**BVPS CONVERSION TO IMPROVED STANDARD
TECHNICAL SPECIFICATIONS (ISTS)**

SECTION 3.7 PLANT SYSTEMS

CHANGES TO THE ISTS

MARKUPS TO SHOW BVPS PLANT SPECIFIC DIFFERENCES
 &
 JUSTIFICATION FOR DEVIATION (JFD)
 FROM THE STANDARD TS

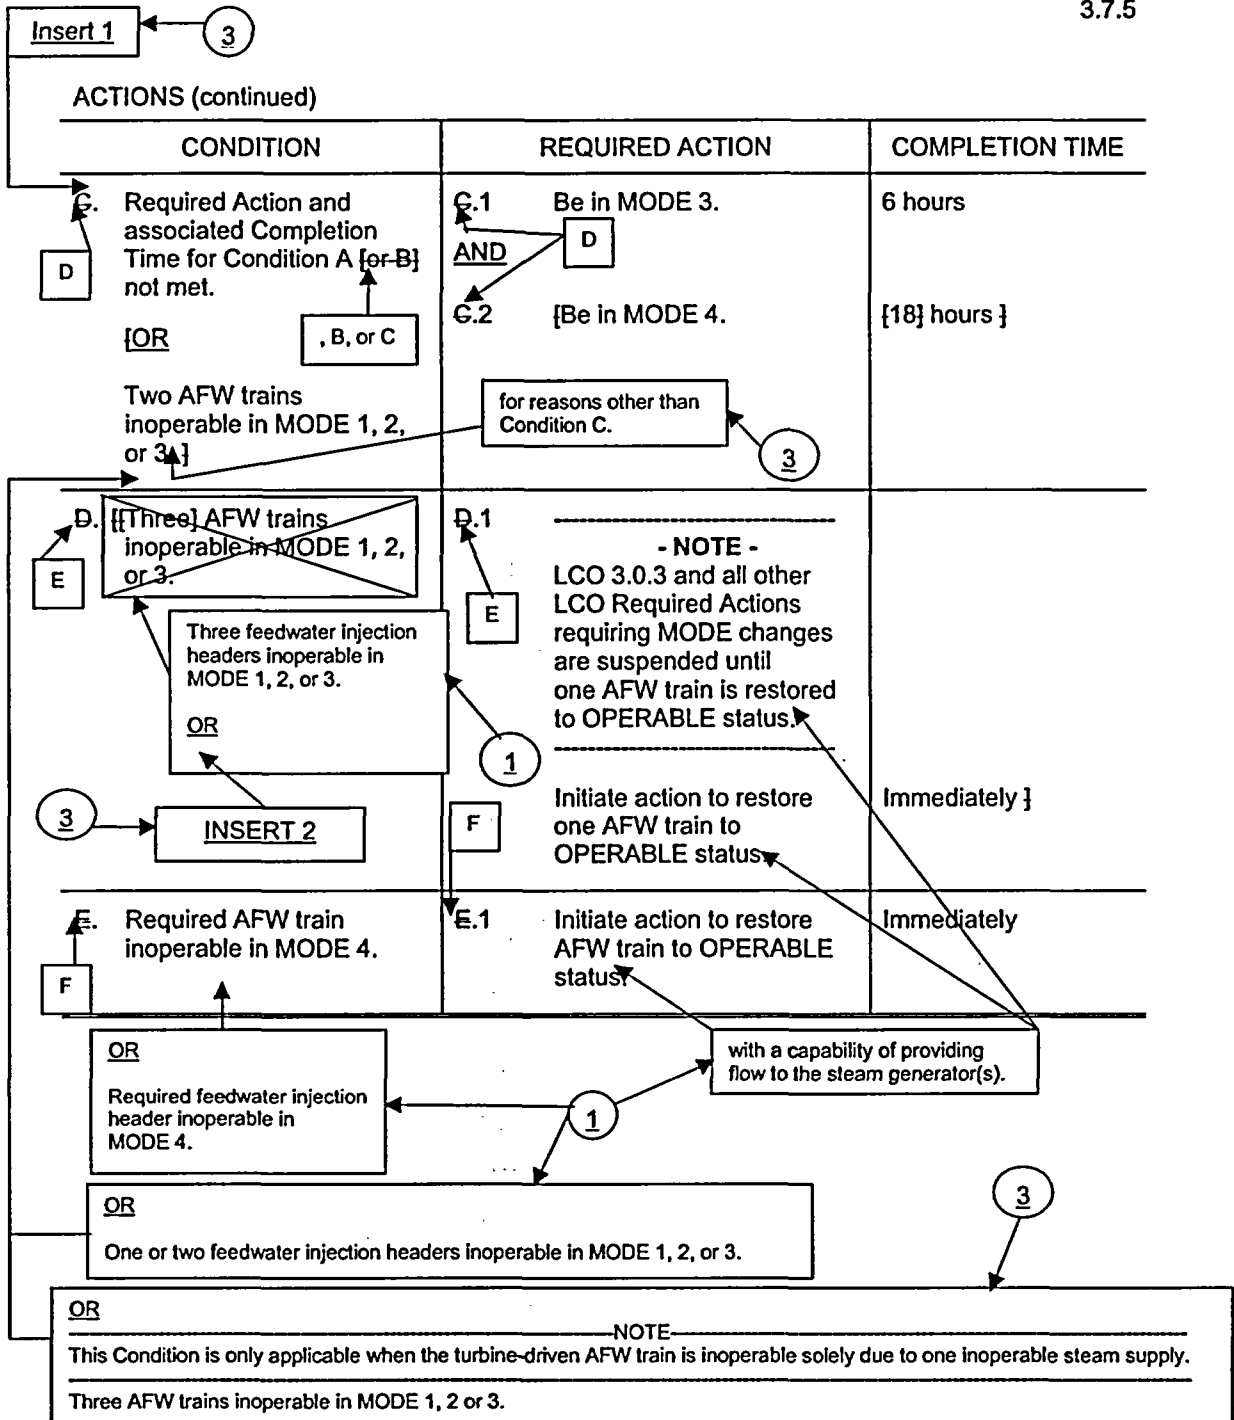
CONDITION	REQUIRED ACTION	COMPLETION TIME
<p>A. One steam supply to turbine driven AFW pump inoperable.</p> <p><u>OR</u></p> <p>- NOTE - Only applicable if MODE 2 has not been entered following refueling.</p> <p>One turbine driven AFW pump inoperable in MODE 3 following refueling.</p>	<p>A.1 Restore affected equipment to OPERABLE status.</p> <p>Turbine driven AFW train inoperable due to one inoperable steam supply in MODE 1, 2 or 3.</p> <p>B.1</p> <p>-NOTE- Only applicable if both supply headers are OPERABLE.</p> <p>Realign OPERABLE AFW pumps to separate train supply headers.</p> <p><u>AND</u></p>	<p>7 days</p> <p><u>AND</u></p> <p>10 days from discovery of failure to meet the LCO-}</p> <p>2 hours</p>
<p>B. One AFW train inoperable in MODE 1, 2, or 3 {for reasons other than Condition A}.</p>	<p>B.1 Restore AFW train to OPERABLE status.</p>	<p>72 hours</p> <p><u>AND</u></p> <p>{10 days from discovery of failure to meet the LCO-}</p>

The 24 hour Completion Time is applicable to plants that can no longer meet the safety analysis requirement of 100% AFW flow to the SG(s) assuming no single active failure and a FLB or MSLB results in the loss of the remaining steam supply to the turbine driven AFW pump.

The 48 hour Completion Time is applicable to plants that can still meet the safety analysis requirement of 100% AFW flow to the SG(s) assuming no single active failure and a FLB or MSLB results in the loss of the remaining steam supply to the turbine driven AFW pump.

situations. Condition C as modified by TSTF-412 provides two Completion Times to address the situation where the flow assumed in the safety analysis can still be met (48 hours) and where the required flow can not be met (24 hours). The applicable Completion Time is selected for the BVPS design.

3.7.17 - 1

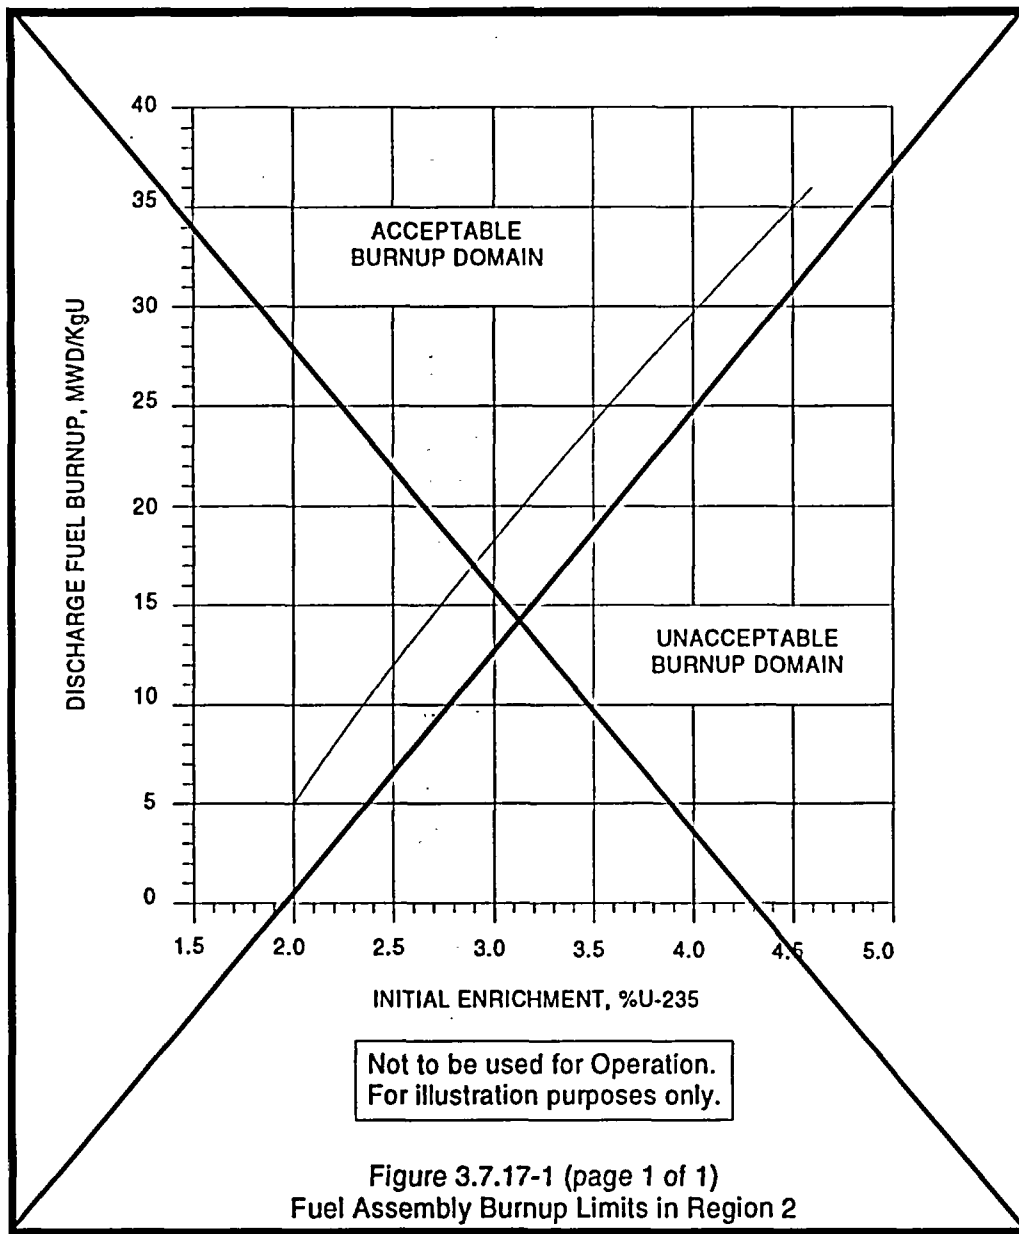
The combination of initial enrichment and burnup of each fuel assembly stored in [Region 2] shall be within the Acceptable [Burnup Domain] of Figure 3.7.17-1 or in accordance with Specification 4.3.1.1.

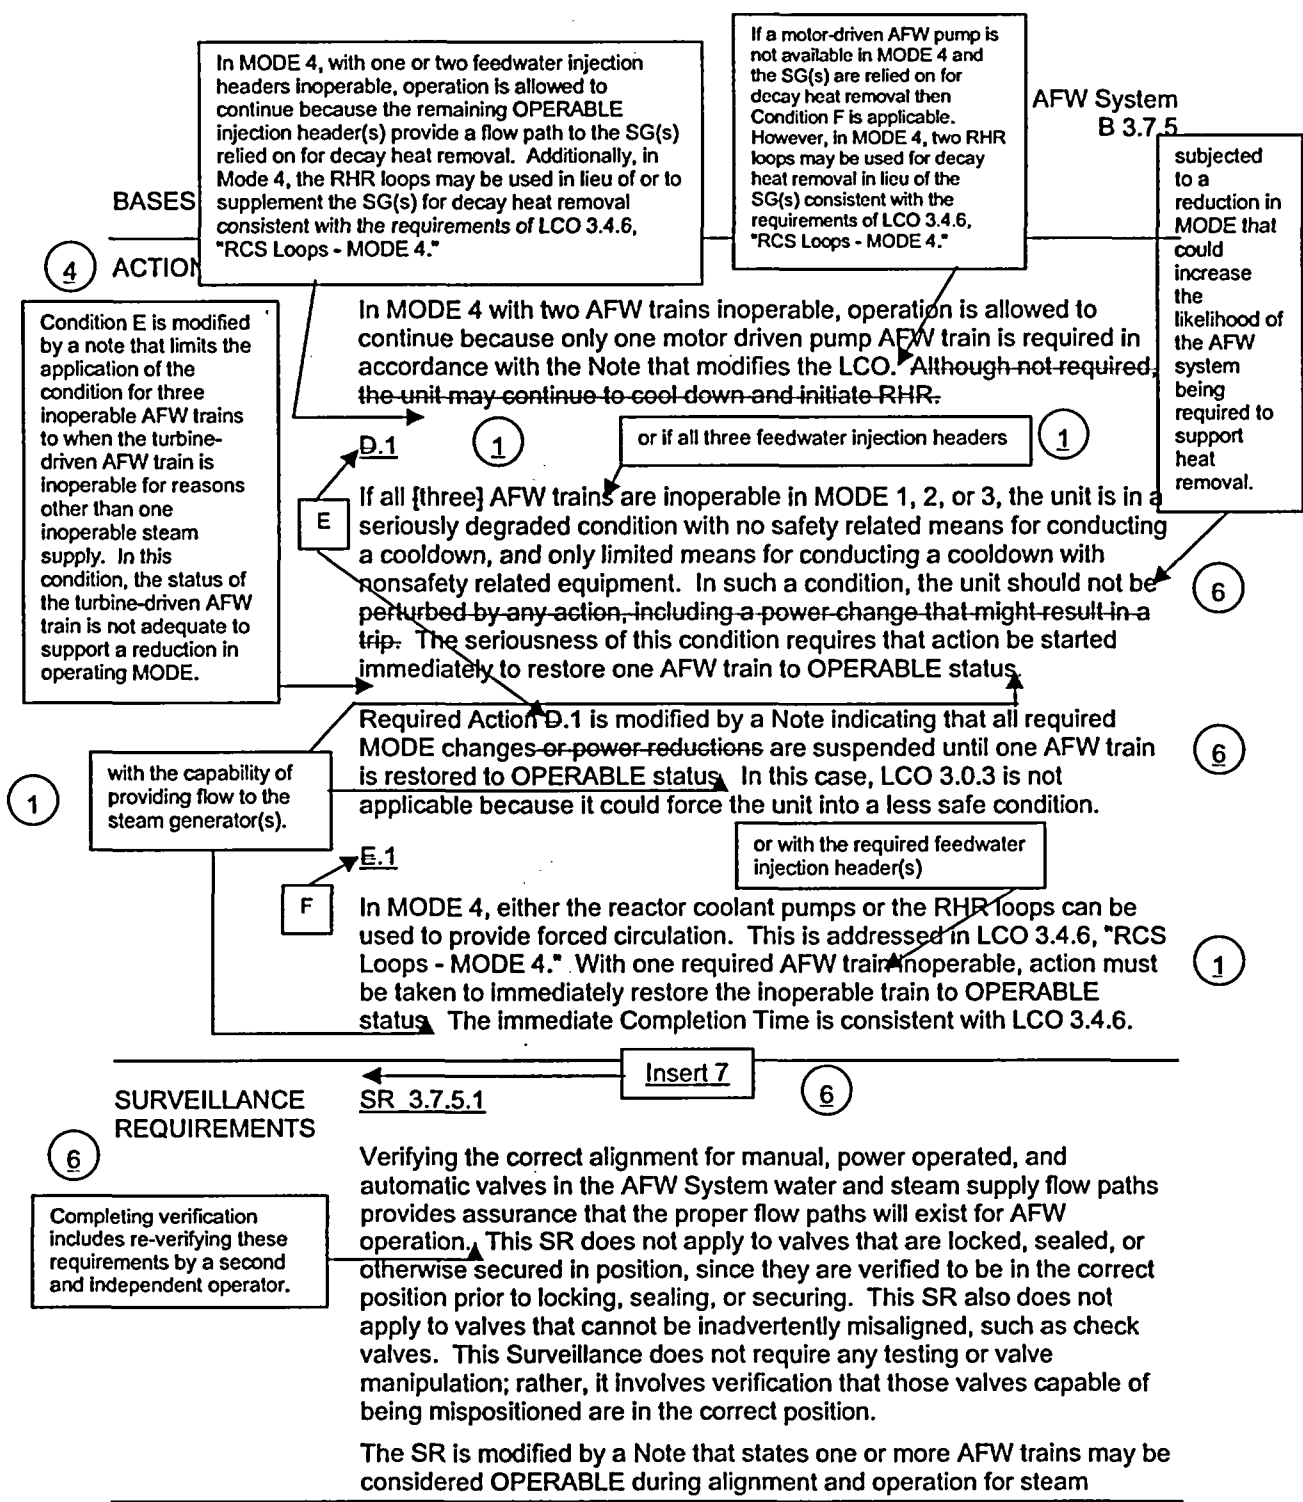
- If two AFW trains are inoperable in MODE 1, 2, or 3 for reasons other than Condition C, or
- If one or two feedwater injection headers are inoperable in MODE 1, 2, or 3, or
- If three AFW trains are inoperable in MODE 1, 2 or 3, but the turbine-driven AFW pump is inoperable solely due to one inoperable steam supply header

C.1 and C.2 D.1 and D.2 , B.1, B.2, C.1, or C.2

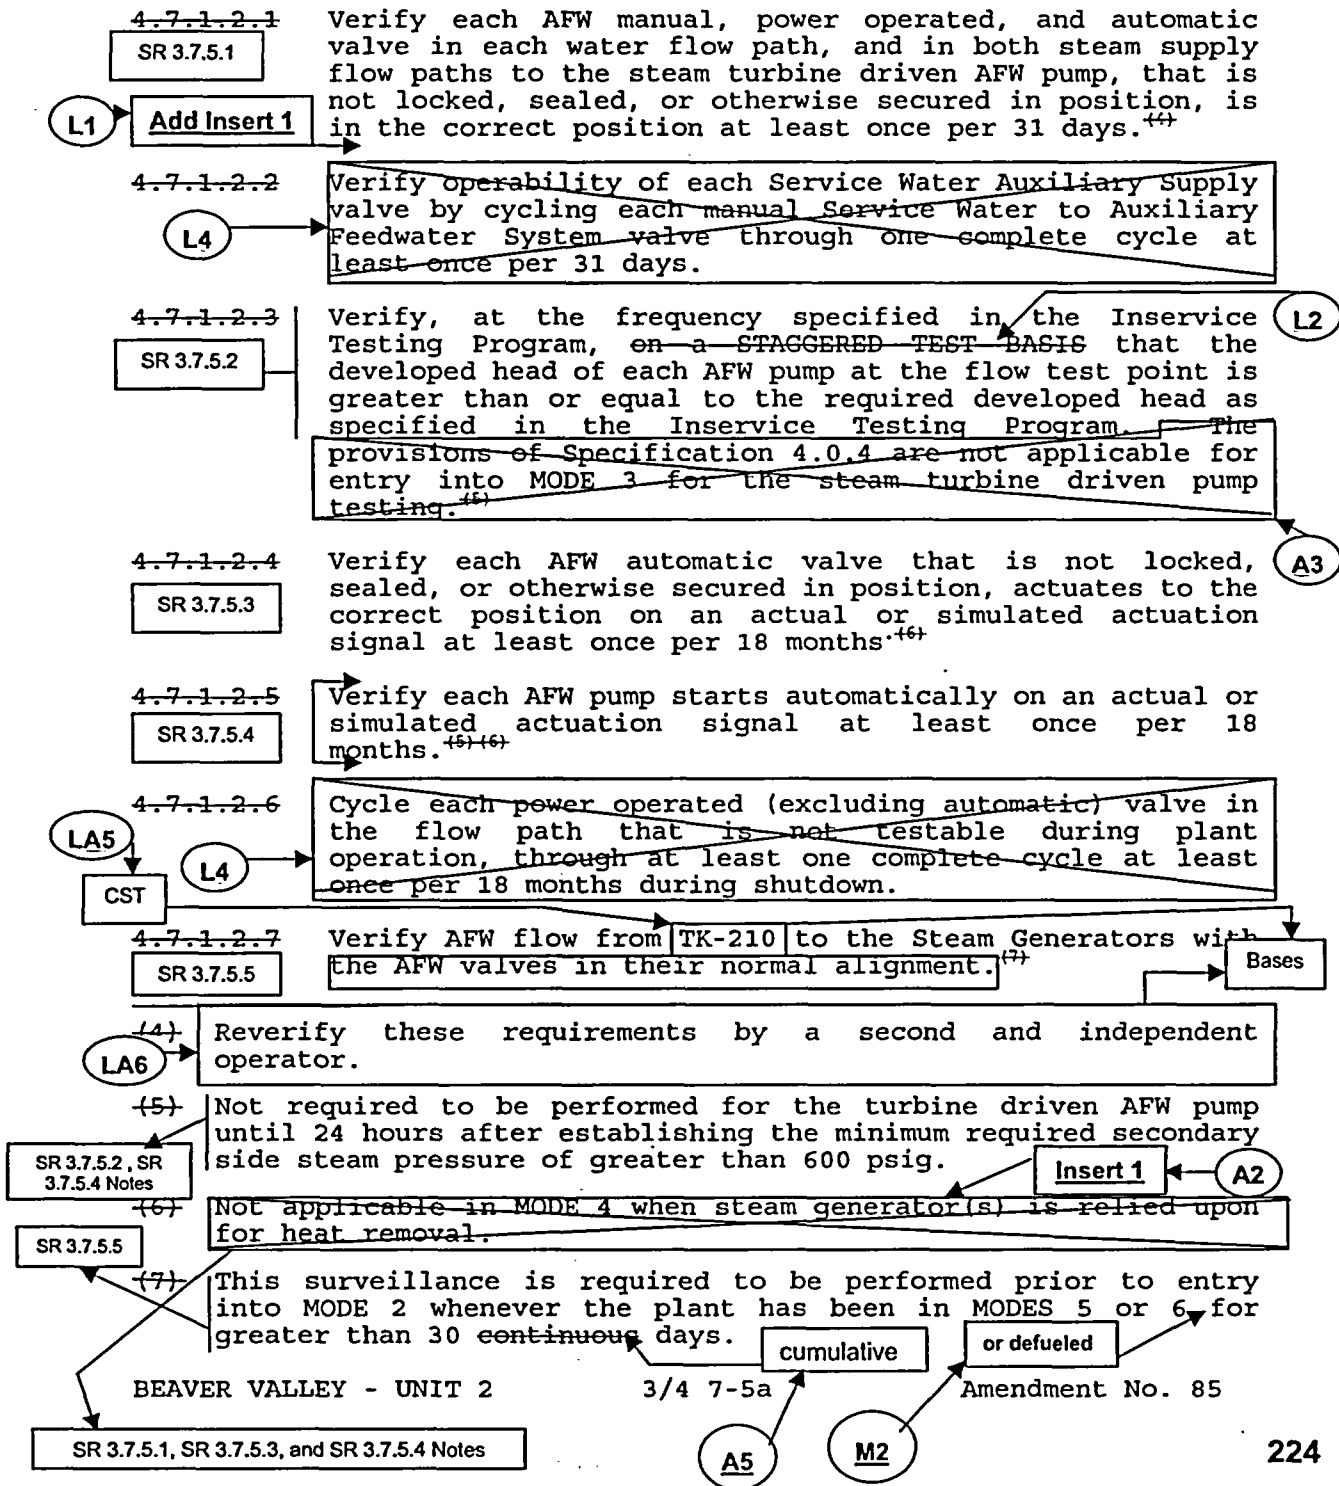
(2) This time period may be extended for up to 96 hours for the turbine driven AFW pump provided that the plant has not entered MODE 2 following a refueling outage.

(3) LCO 3.0.3 and all other LCO ACTION statements requiring MODE changes are suspended until one AFW train is restored to OPERABLE status.

COND. A Actions & NOTE & COND. D Actions ← **L6**
